Memorandum to the City of Markham Committee of Adjustment

May 11, 2018

File: A/47/18
Address: 3 Sunflower Crt Thornhill
Applicant: 2574023 Ontario Inc. (Amir Meysam Nahvi)
Agent: Avesta Design Group Inc. (Mohammad Ashouri)
Hearing Date: Wednesday May 30, 2018

1 EAST ELEVATION
AR-06 SCALE : 1/8" = 1'-0"

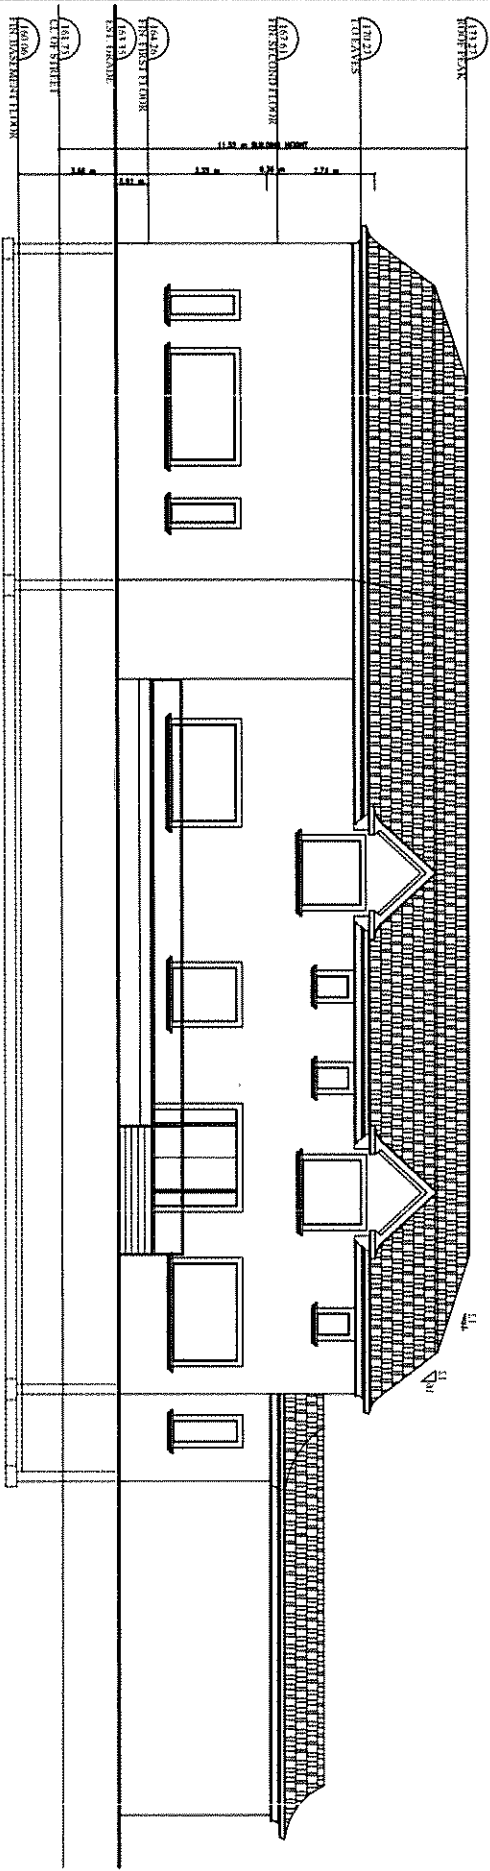
The applicant is requesting relief to permit a maximum building height of 11.52 m (37.79 ft), whereas the By-law permits a maximum building height of 9.8 m (32.15 ft). This represents an increase of approximately 1.72 m (5.64 ft), or 14.9%.

The requested variance does not apply to approximately 9.4 m (30.83 ft) wide garage portion of the front façade. It is the opinion of staff that the vertical massing of the proposed dwelling is in keeping with recent development trend in the community and is generally consistent with other new infill residential developments in the area.

1 CROSS SECTION
AR-09
SCALE : $\frac{3}{8}'' = 1'-0''$

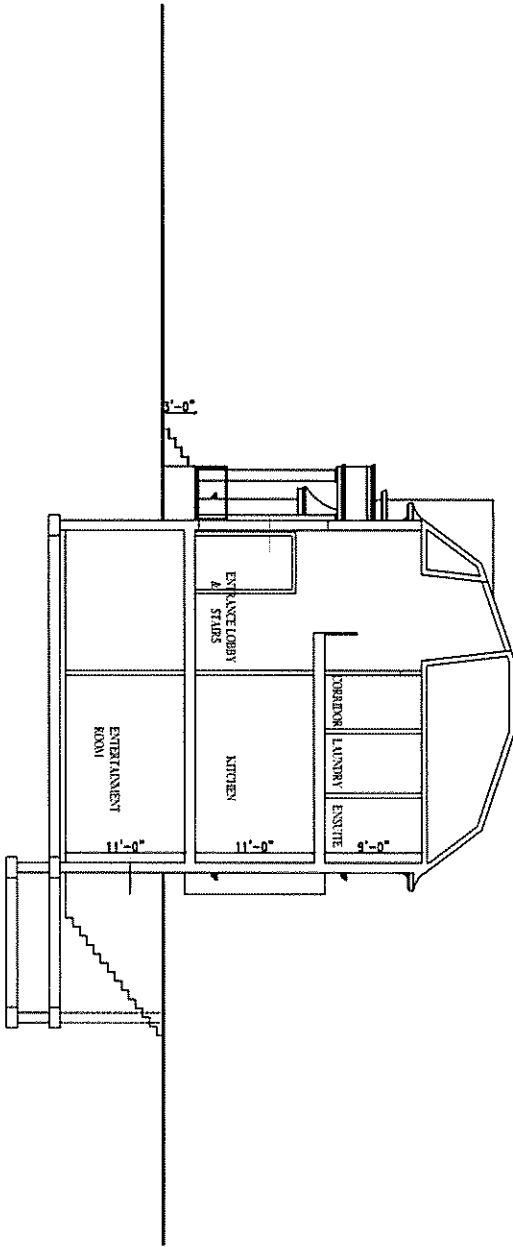
The By-law calculates building height using the vertical distance of building or structure measured between the level of the crown of the street and highest point of the roof surface. It should be

noted that the proposed grade of the front of the house is approximately 1.6 m (5.24 ft) above the crown of road.
